Access Compliance Report

Public Rights-of-Way

(Curb Ramps)

Intersection ID: 48771	Main Street: LUMBER_LN	Cross Street: TURNING_WHEEL_DR	Location: NW
ADA ID: AC2F97897F9D	Ramp Type: PerpDiag	Initial Pass/Fail: Fail	Overall Compliance: No
Severity Score: 8.75			
Codes/Mitigation Info/Possible Solution		Field Measurements/Component Compliance

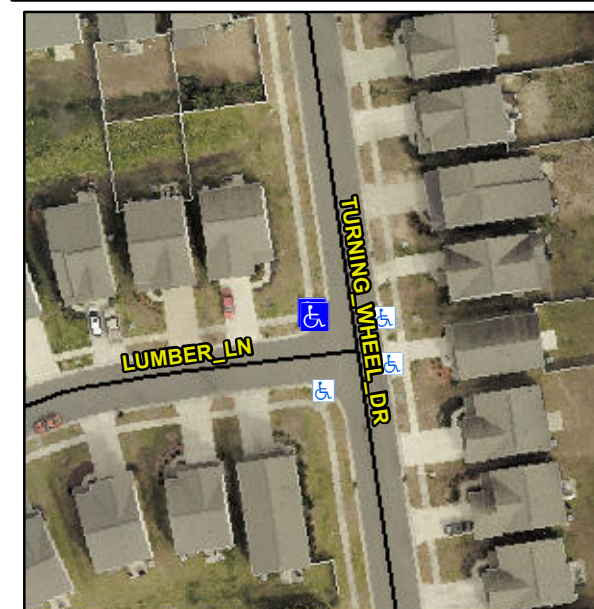
Not Found, R304.5.1

Compliance	Description	Data	Compliance	Description	Data
N/A	Ramp Length (in)	69.5	Yes	Ramp Slope (%)	5.7
No	Ramp Width (in)	47.0	Yes	Ramp XSlope (%)	0.9
N/A	Flare Type LT	N/A	N/A	Flare Type RT	N/A
N/A	Flare Slope LT (%)	N/A	N/A	Flare Slope RT (%)	N/A
N/A	Flare Traversable LT?	N/A	N/A	Flare Traversable RT?	N/A
N/A	Landing Length (in)	N/A	N/A	DWS Provided?	N/A
N/A	Landing Width (in)	N/A	N/A	DWS Contrast?	N/A
N/A	Landing Slope (%)	N/A	N/A	DWS Length (in)	N/A
N/A	Landing X Slope (%)	N/A	N/A	DWS Full Width?	N/A
N/A	Landing Curb? (Y/N)	N/A	N/A	DWS Offset (in)	N/A
N/A	Shared Landing?	N/A			
N/A	Gutter Ponding?	N/A	N/A	Gutter Slope (%)	N/A
N/A	Gutter Lip Ht (in)	N/A	N/A	Gutter X Slope (%)	N/A
N/A	Painted X Walk1?	No	N/A	Painted X Walk2?	No
	X Walk 1 Direction	To S		X Walk 2 Direction	To E
N/A	X Walk 1 Width (in)	N/A	N/A	X Walk 2 Width (in)	N/A
	X Walk 1 Slope (%)	3.8		X Walk 2 Slope (%)	4.1
	X Walk 1 X Slope (%)	2.5		X Walk 2 X Slope (%)	2.5

Remove & Replace Curb Ramp With Two New Directional Ramps or Equivalent.
